**Inspection Report
5 Sam Sing Street, Waterloo**

**Council investigation officer Inspection and Recommendation Report
Clause 17(2), Part 8 of Schedule 5, of the Environmental Planning and
Assessment Act 1979 (the Act)**

**Re: INSPECTION REPORT
'TOWER RESIDENCES'
5 SAM SING STREET, WATERLOO ("the premises")**

5 Sam Sing Street Waterloo

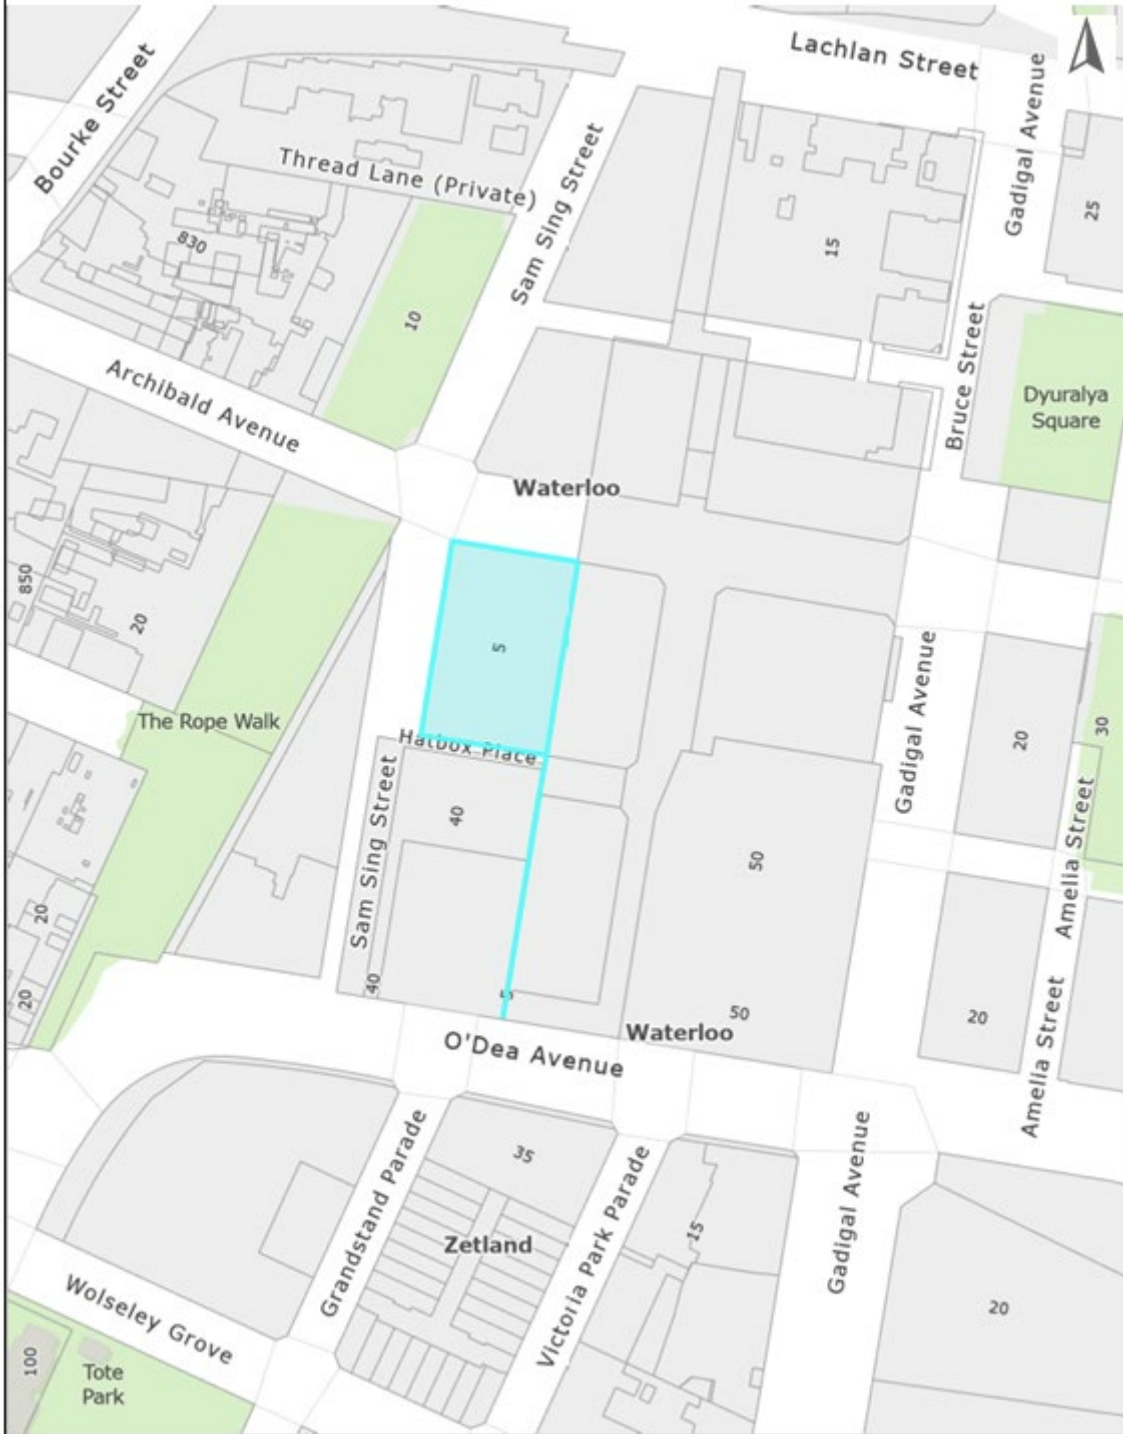
An inspection of the buildings undertaken by a Council investigation officer in the presence of the Building Manager on the 7 May 2024 revealed that most of the items identified by NSW Fire and Rescue were rectified prior to the inspection, however the premises remains deficient in fire safety provisions in the following areas:

- (i) Deficient fire stopping provided to service penetrations.
- (ii) Inadequate fire separation between the garbage room and the carpark.

As a result of site inspection undertaken by Council's investigation officers it was determined to issue the owners of the building a compliance letter of instruction to rectify the identified fire safety deficiencies noted by Council and FRNSW.
